PRODUCT MODELS AFFECTED					
<input checked="" type="checkbox"/> PC1	<input type="checkbox"/> PC3	<input type="checkbox"/> Titan	<input type="checkbox"/> Work Cages	<input type="checkbox"/> Platforms	<input type="checkbox"/> Astro
<input type="checkbox"/> Hoist Accessories	<input type="checkbox"/> Platform Accessories	<input type="checkbox"/> Rigging Accessories	<input type="checkbox"/> Safety Accessories

SUB COMPONENT
Overspeed Safety Device - Flywheel Assembly

703746 - Field Service Instruction - PC1 Flywheel Update

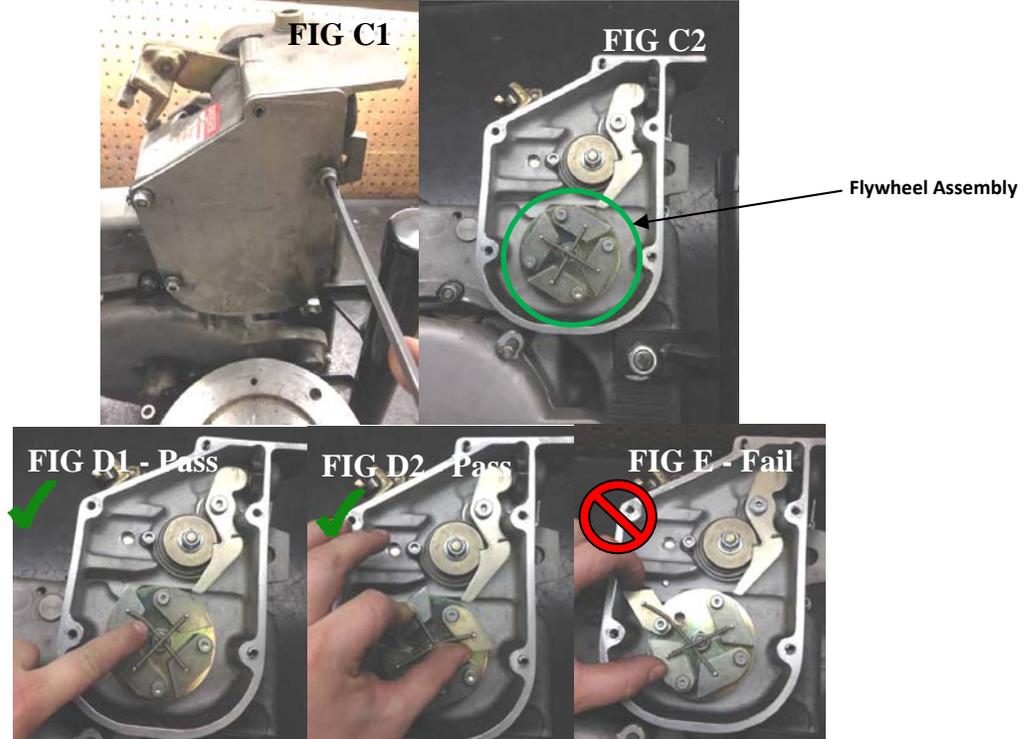
After performing tests on the PC1 to simulate if a flywheel counterweight pin falls out or shears off, it was found that the counterweight may get caught on surrounding structure (ie: housing). This could result in a condition where the flywheel will not trip the overspeed safety trip trigger. In the unlikely event of a loss of traction of the suspension rope in the traction sheave, or a drive train failure leading to a freewheeling traction sheave, the Overspeed Safety Device Cam will not engage and stop motion of the hoist.

The pin non-conformance may not be detected while performing the Daily Test Requirements as outlined in Power Climber Operators Manual. Additional steps are required to ensure detection of a missing or a sheared pin.

1. With power disconnected, remove the motor from the hoist and remove the Flywheel Cover (Fig C1). Locate the Flywheel Assembly (See Fig C2). **Manually rotate each flywheel counterweight (4 Total) on Flywheel Assembly** of the Overspeed Safety Device to ensure that their rotation past the outer diameter of the flywheel is limited as shown in Fig D1 & D2 below. If it can rotate too far as shown in Fig E, the Flywheel does not pass inspection and **hoist must be removed from service immediately until update is applied.**

1. PC1 Flywheel Weight Retention Plate Kit (p/n 720202-1) must be installed by a technician that holds a valid Hoist Maintenance Training Certification from Power Climber, or hoist must be removed from service.
2. At time the time of service, record the serial number of hoists updated and send them to ProductSupport@PowerClimber.com.
